A G E N D A
CANBY PLANNING COMMISSION
REGULAR MEETING
CITY COUNCIL CHAMBERS
MONDAY, JUNE 26, 1995
7:30 P.M.

DR 95-09, an application by Mark Crorey [applicant] and Michael Vigus [owner] for approval to construct a 2,492 square foot building to be used for either retail commercial use or office use. The property is located on the northwest corner of S. Ivy and S.W. 2nd Avenue [Tax Lot 8000 of Tax Map 3-1E-33CD]. *Continued from June 12, 1995*

DR 95-11, an application by Peck Smiley Ettlín Architects [applicant] and Canby Fire District No. 62 [owner] for approval to construct a 14,215 square foot 1-story masonry fire station with double loaded 5-bay apparatus bay, administrative offices, living quarters, and meeting space. The site is located on the west side of S. Pine Street, between S.E. 2nd Avenue and S.E. 3rd Avenue [Tax Lot 804 of Tax Map 3-1E-33DA].

2ND & IVY PLOT PLAN

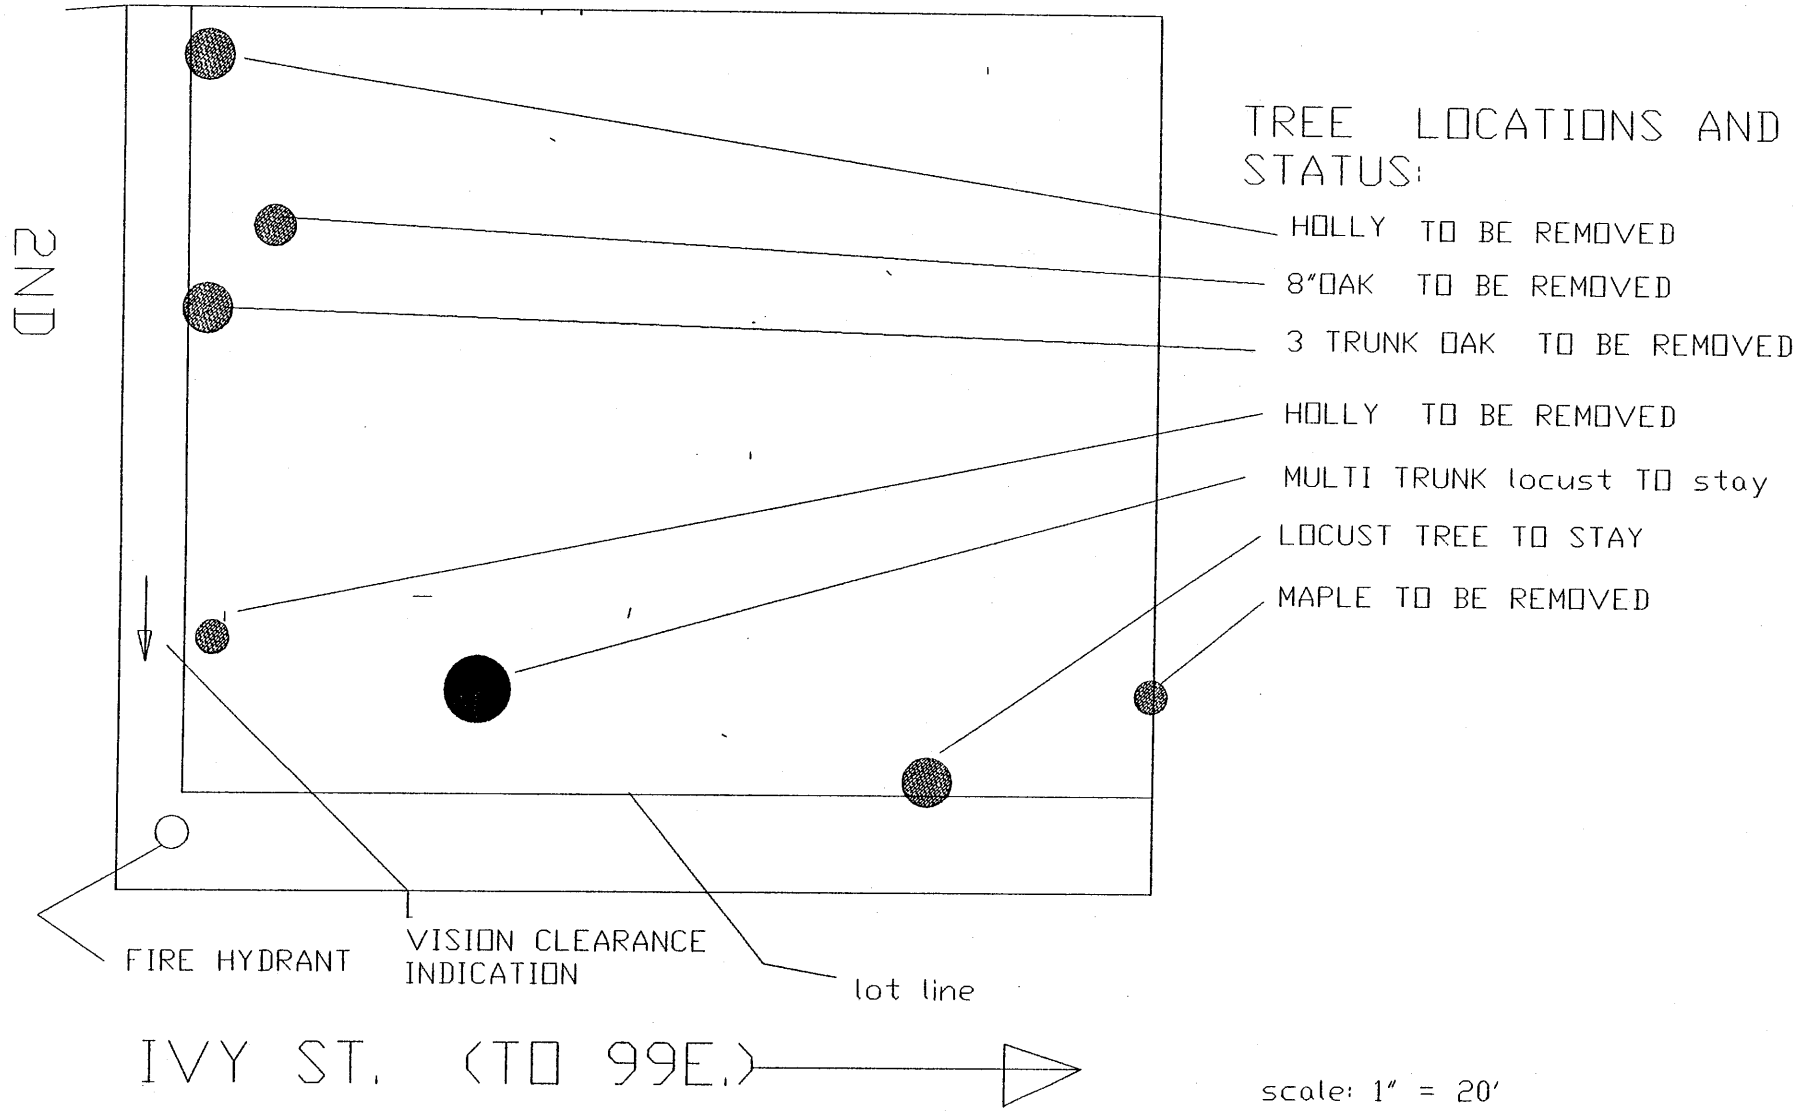
The roof on the porch of the home on the property immediately to the west encroaches on this property by approximately 1.5 feet. The site plan shows the

There is no specific use proposed for the building. The number of parking spaces proposed, twelve (12), is sufficient to provide enough parking for all commercial uses except restaurants. Use of a small portion of the building for a restaurant (ice cream vendor, for example) is theoretically possible, provided that the parking demand generated by the use in the remaining portion of the building is small enough to compensate for the higher parking demand of the restaurant use. The parking ratio that is proposed is 5.0 spaces per 1,000 square feet of building space.

Improvements to S. Ivy Street will be necessary. No additional right-of-way dedication along S. Ivy Street (other than possible curb return dedication at the intersection of 2nd Ave. and Ivy St.) will be needed, as the current right-of-way width of sixty (60) feet meets the minimum standards for arterial right-of-way widths as provided in the City's adopted Transportation Master Plan. Needed improvements along S. Ivy include curbs, sidewalks, some street widening, and storm drainage. The improvements need to meet the County's as well as the City's standards for construction, as S. Ivy is a County road. A County "Street Construction and/or Encroachment Permit" will be required by the County for the improvements on S. Ivy Street.

1. A detailed landscape plan shall be submitted with the building permit. The detailed landscape plan shall show: the number of plants, plant spacing/location of planting, the type of plants, the size of plants, the schedule of planting, and irrigation plans.
2. Automatic irrigation shall be provided for the lawn landscaping.
3. The walkway in front (on the south-facing side) of the building shall terminate at the door to the building, allowing for a minimum of two (2) feet of backing/turning movement for the northeastern parking space.

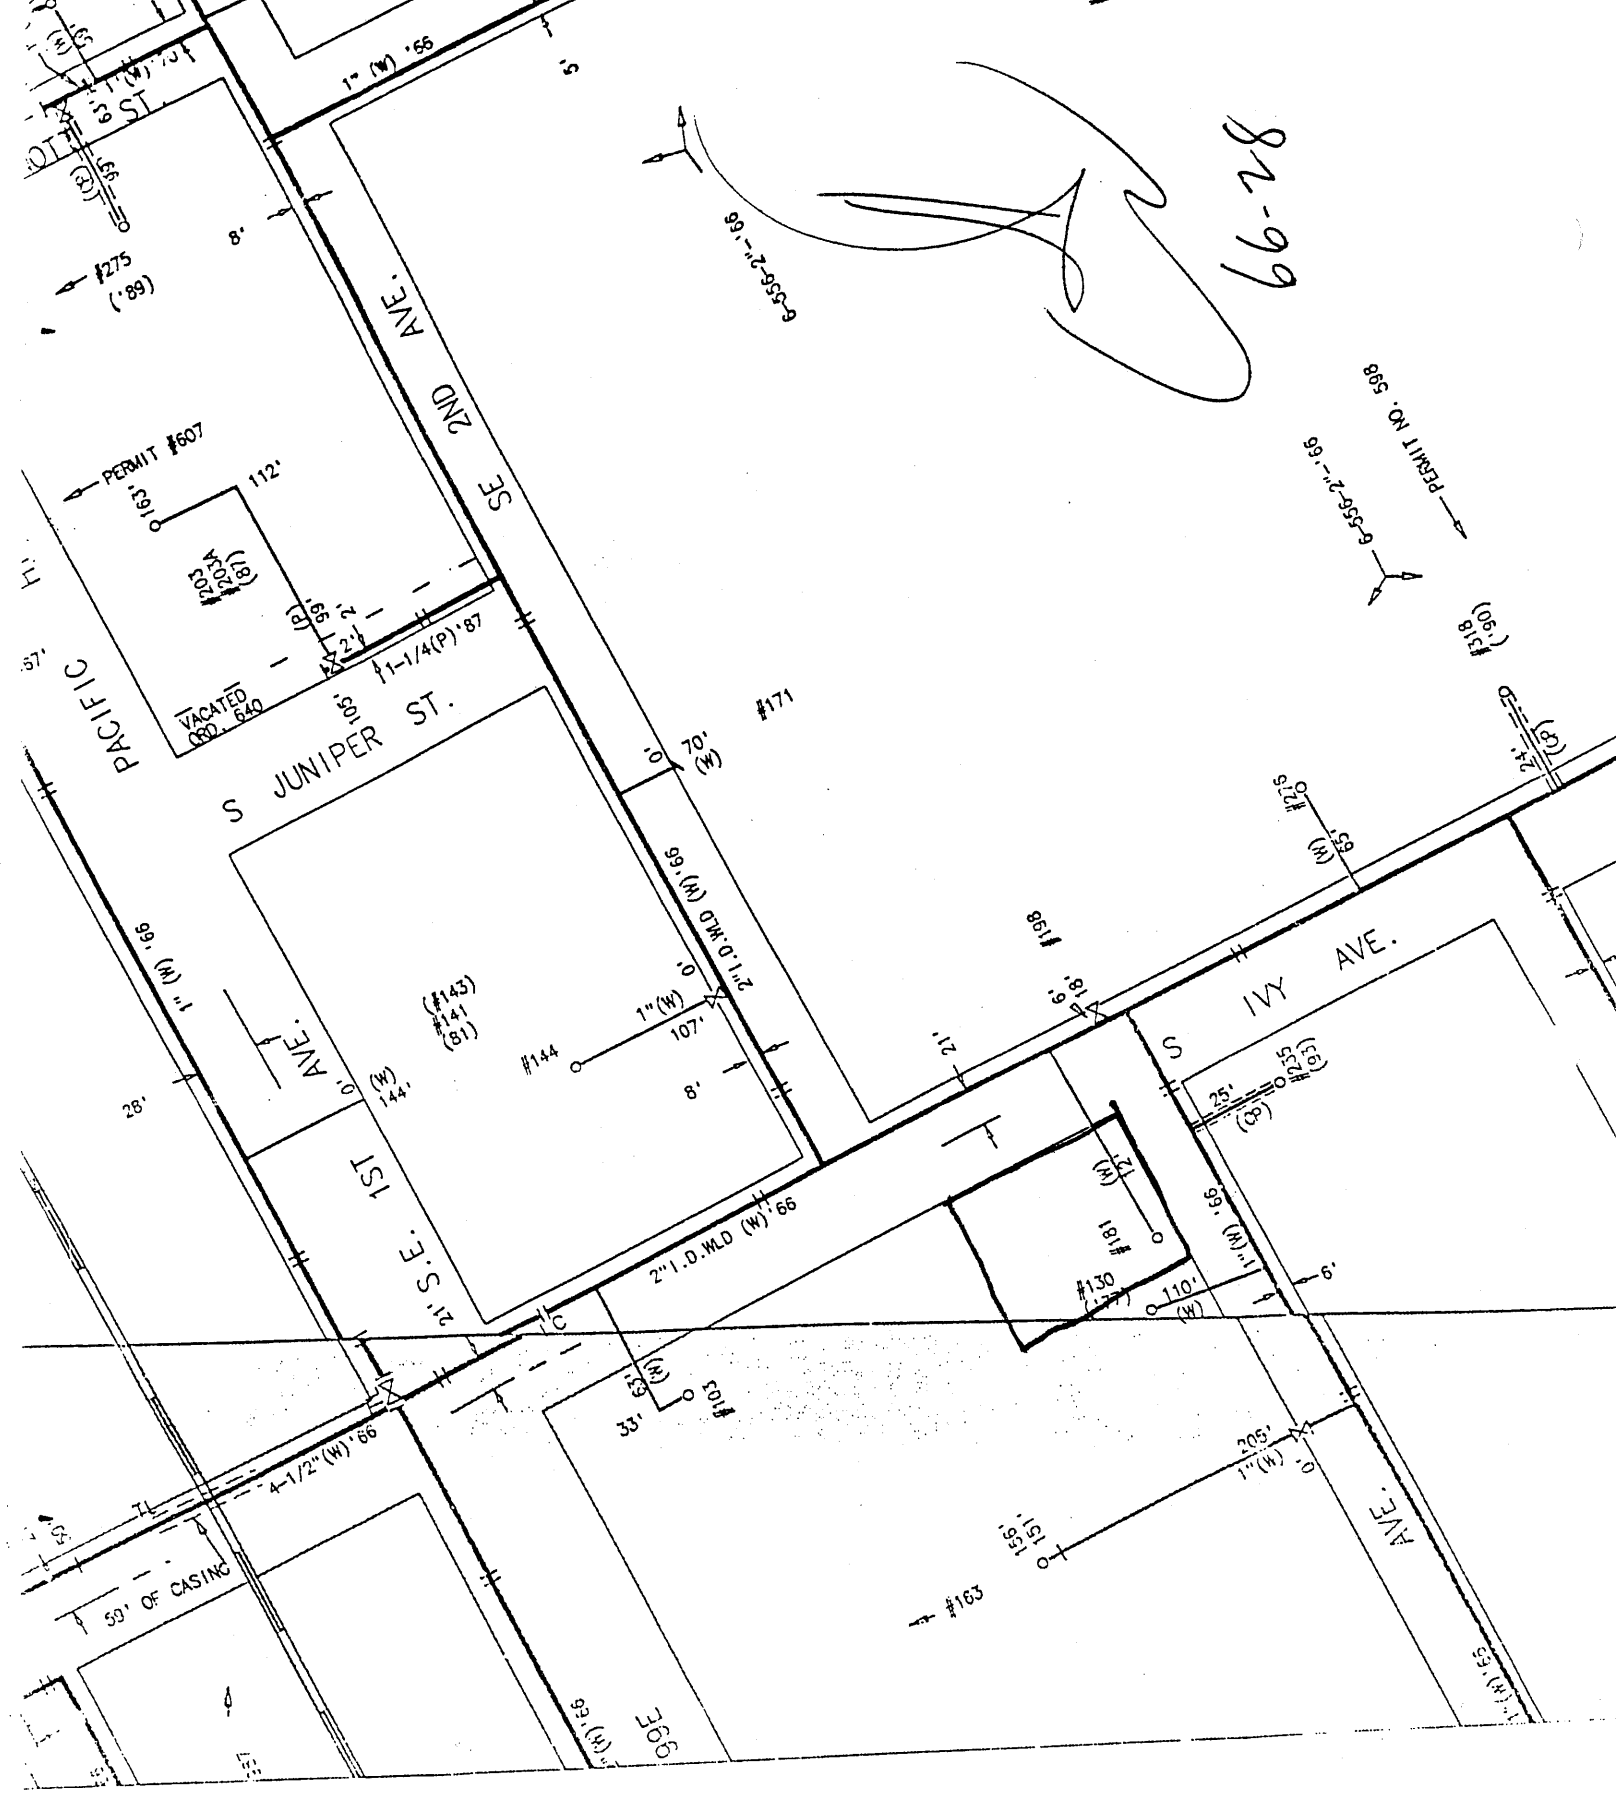
NW Natural Gas has an existing service at this address - (see attached plat) that will need to be abandoned prior to any work starting.
